# Fabrica Knit Composite Ltd.

## Client Summary Report

Observations & Actions

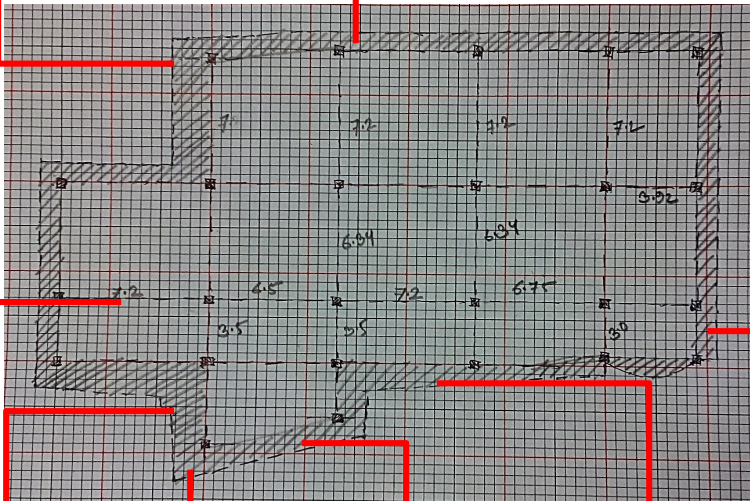
Columns appear to be stressed in excess of normal design limits.

Built-up in toilet zone.

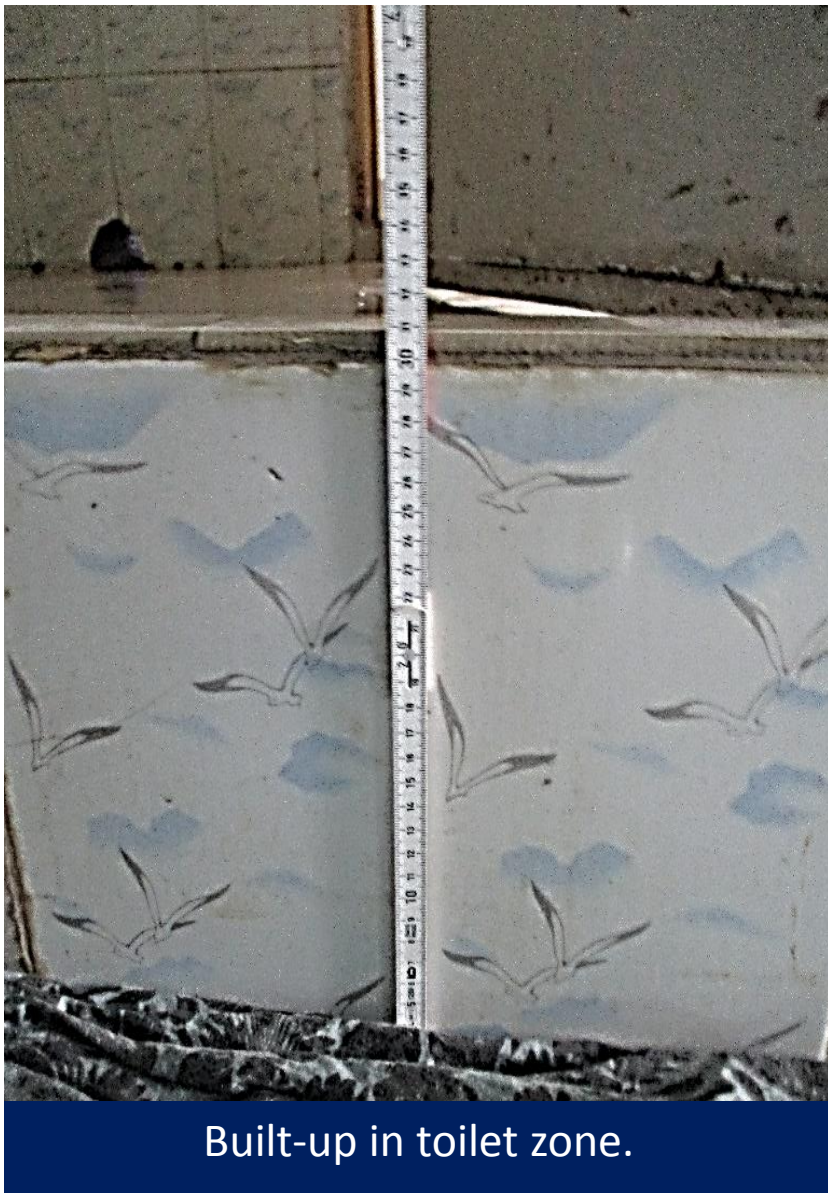
Heavy loads was appeared most of the cantilever area and floor built-ups are found in each toilet zone.

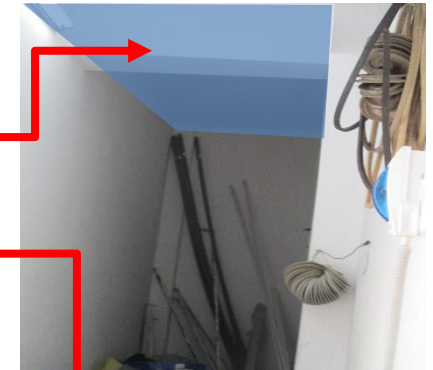
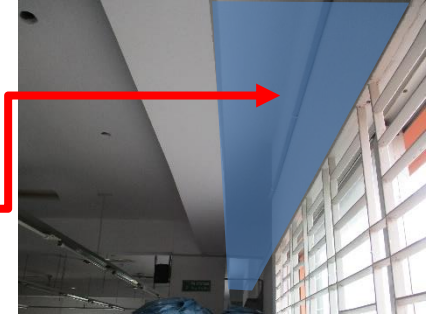
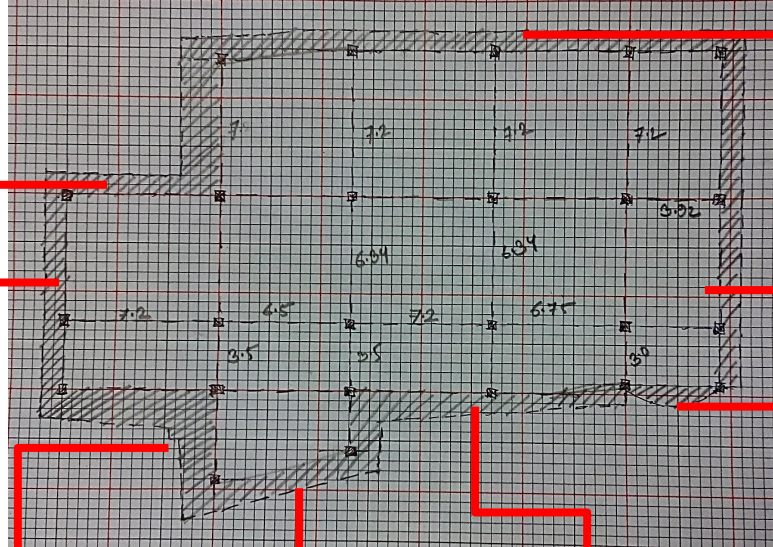
Localized loads on 1<sup>st</sup> floor level

High loads on 3<sup>rd</sup> floor level

Additional Cantilevers in all sides of the building ranging 1.7 m to 1 m

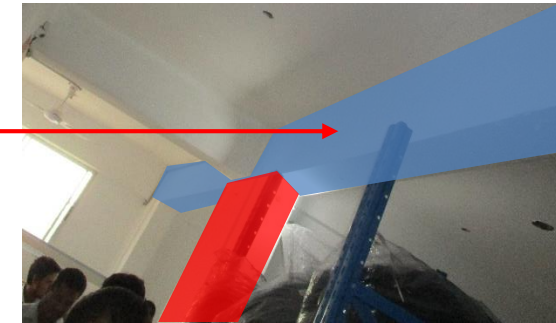
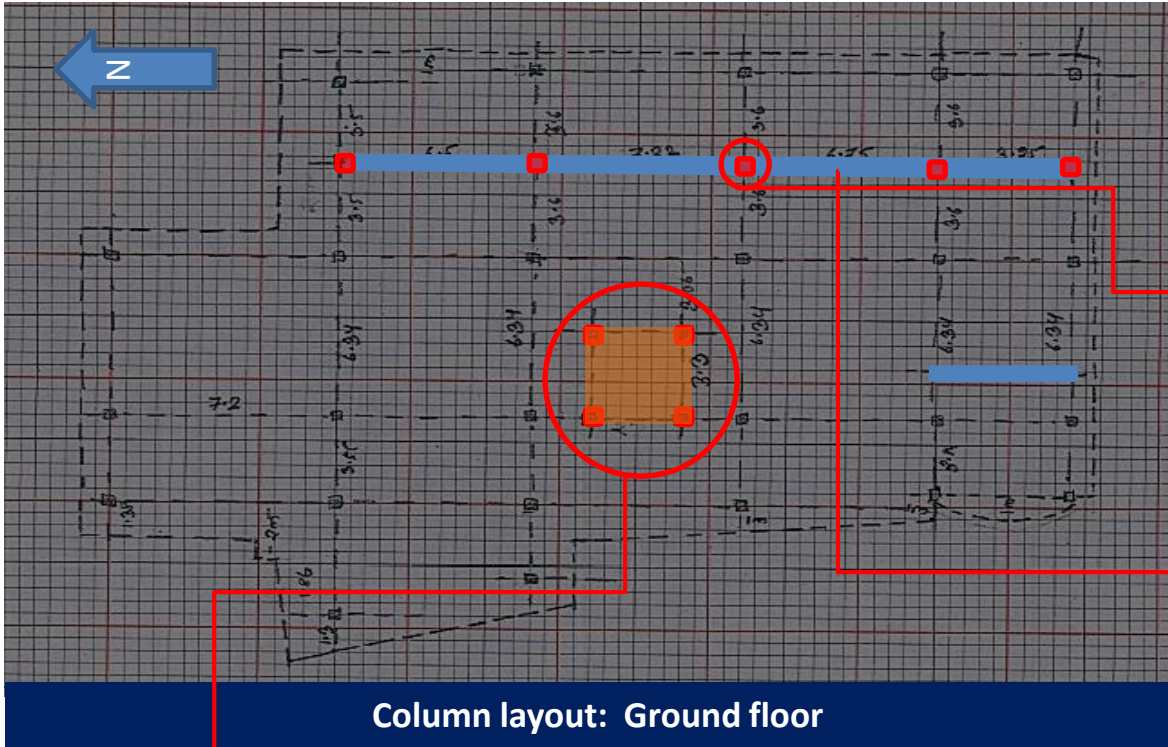
Additional framing at Ground Floor which is not included in approval drawings and structural drawings.

- Additional columns on Ground Floor
- Additional Beams on Ground Floor
- Undocumented ramp on ground floor

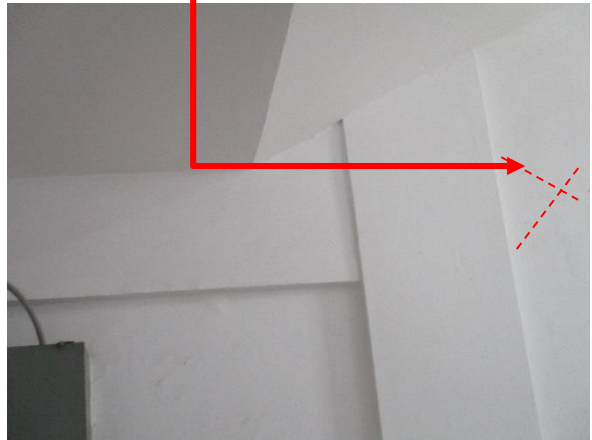
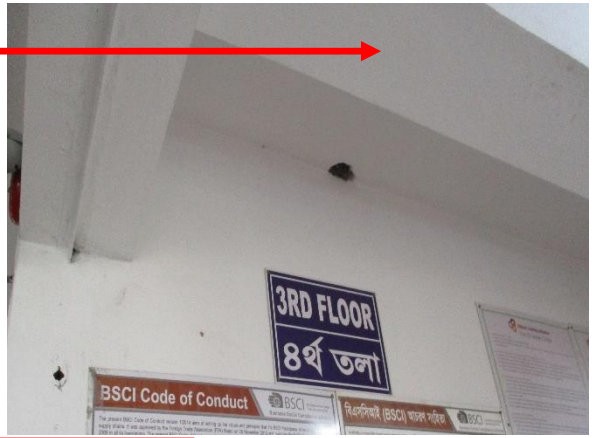
- Deviated columns on typical floor from actual drawing
- Actual arrangement of floor beam
- ✗ Missing Beams in stair core.
- Additional Beam resting on main beam

Beams and columns deviated from original layout in every floor

Circular columns in 1<sup>st</sup> and 2<sup>nd</sup> floor

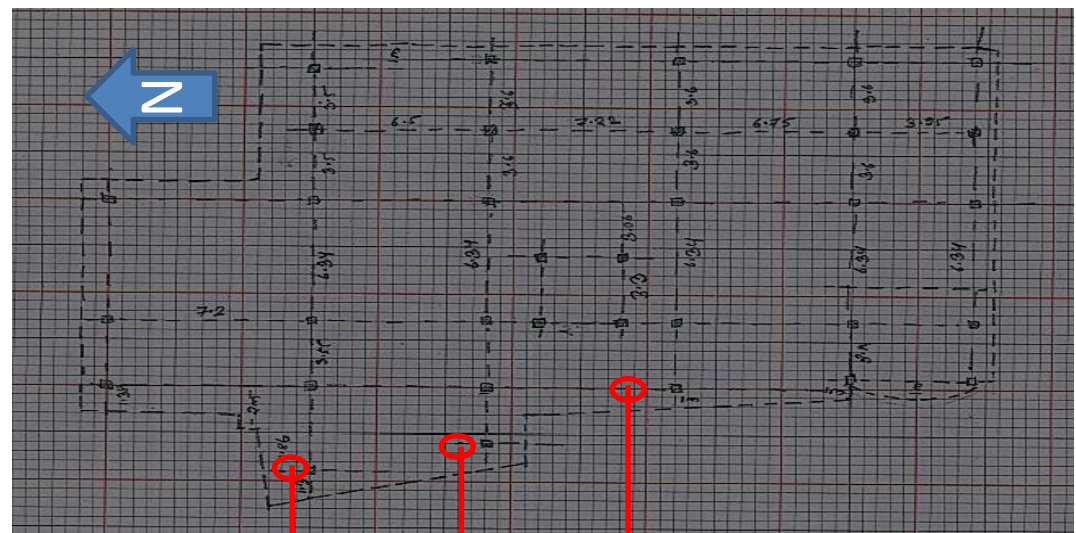
Some columns are found as in circular shape in ground and 1<sup>st</sup> floor which is not shown in structural drawings .

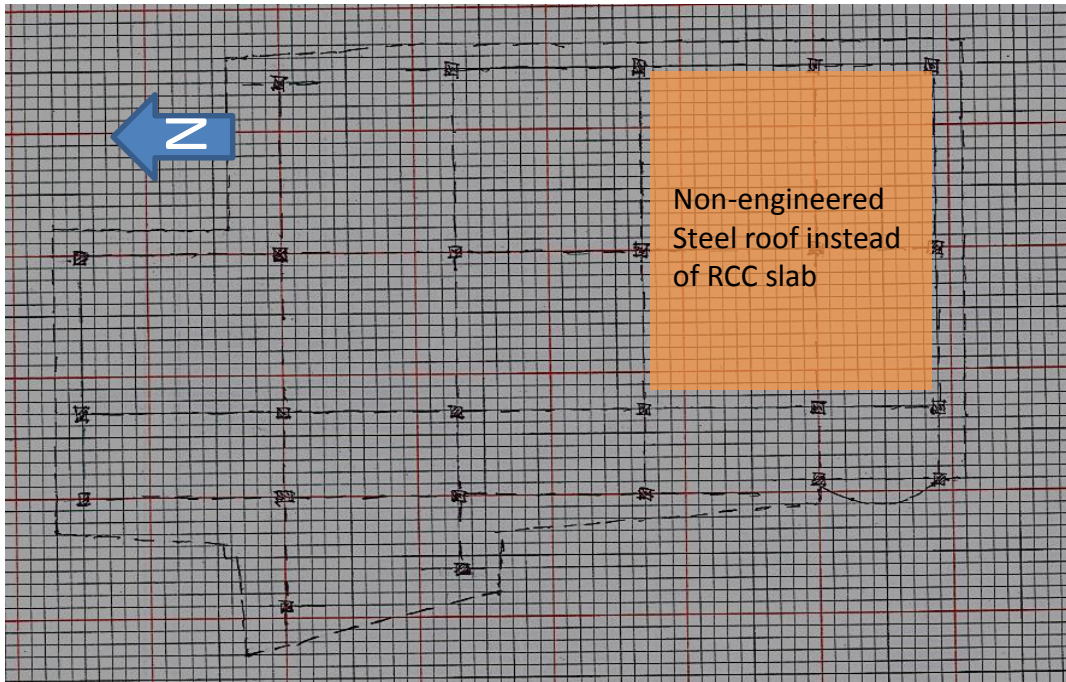
Apparently non engineered steel shed on roof with trapezoidal sheet over steel angel. Poor welded steel connection appeared.

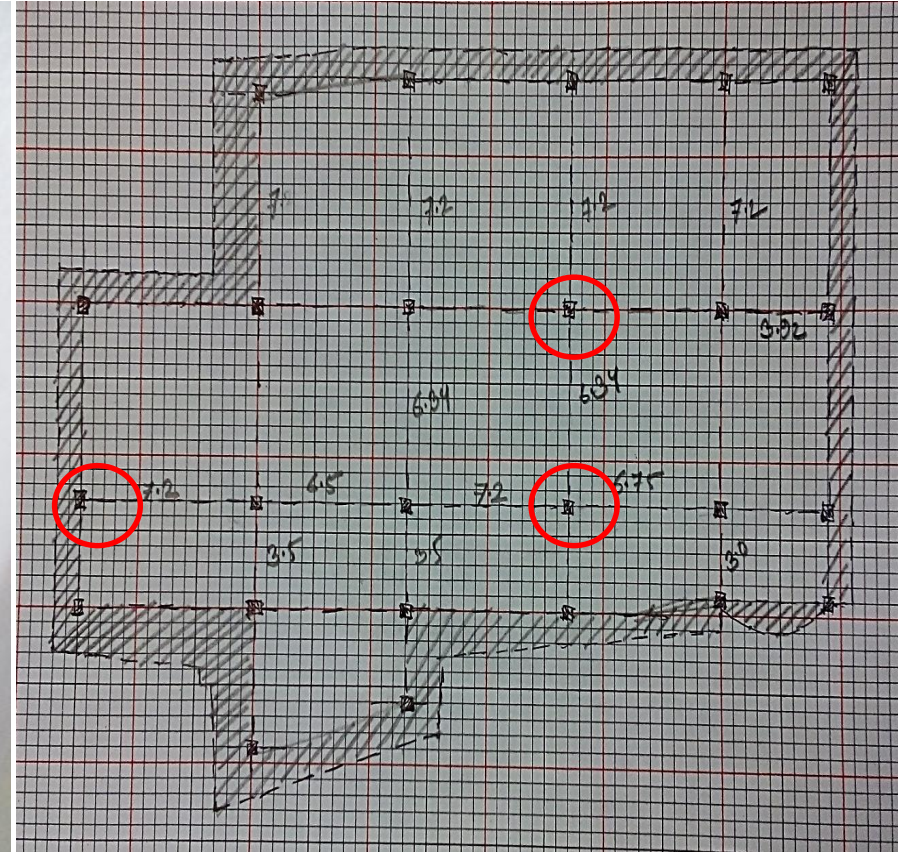
Light weight steel stair between 6<sup>th</sup> floor and roof. Stair supporting steel box column of 40mm X 40mm & Pipe of 75mm columns appeared poorly connected on the floor slab.
